Shift Lever Slide Cover Deformation and Noise During Operation

Service Category Drivetrain

Section Automatic Transmission/Transaxle

YEAR(S)	MODEL(S)	ADDITIONAL INFORMATION
2012 – 2014	Camry, Camry HV

Figure 1.

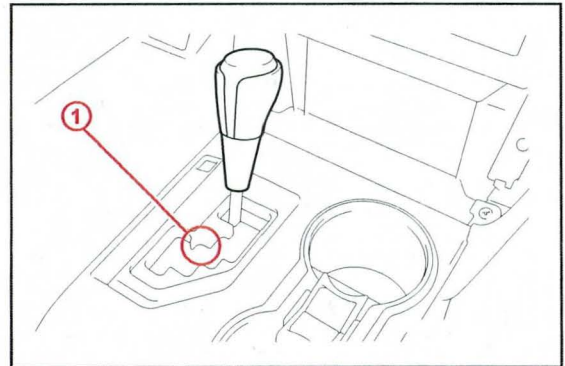
- Damaged slide cover due to distortion/deformation.
- Difficult to move shifter due to interference between the slide cover and the Upper Console Panel assembly (as shown in Figure 1).
- Abnormal shifter noise during operation.

Figure 2. Shift Position Indicator Assembly

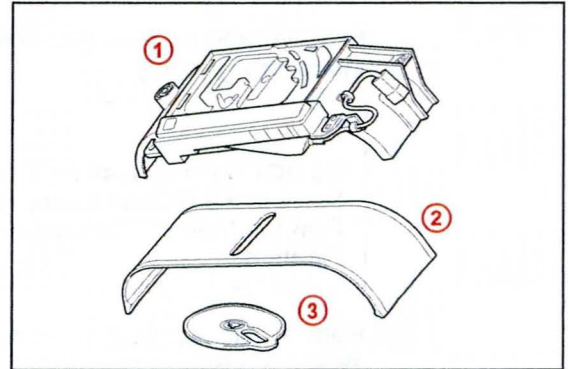
Do NOT replace position indicator slide covers No. 1 and 2 without swapping the entire Shift Position Indicator assembly (as shown in Figure 2).

Remove and replace the Shift Position Indicator assembly and the Upper Console Panel assembly.

Figure 4. Shift Position Indicator Assembly

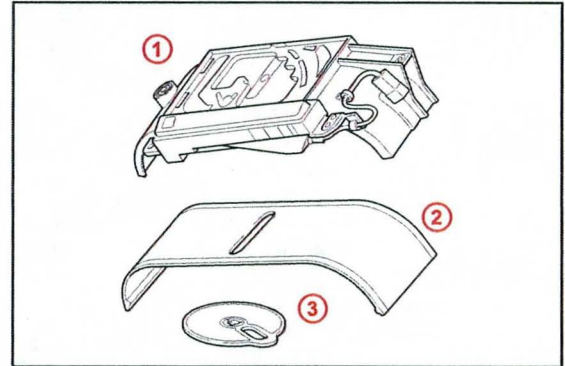
Do NOT replace position indicator slide covers No. 1 and 2 without swapping the entire Shift Position Indicator assembly (as shown in Figure 4).

Remove and replace the Shift Position Indicator assembly.
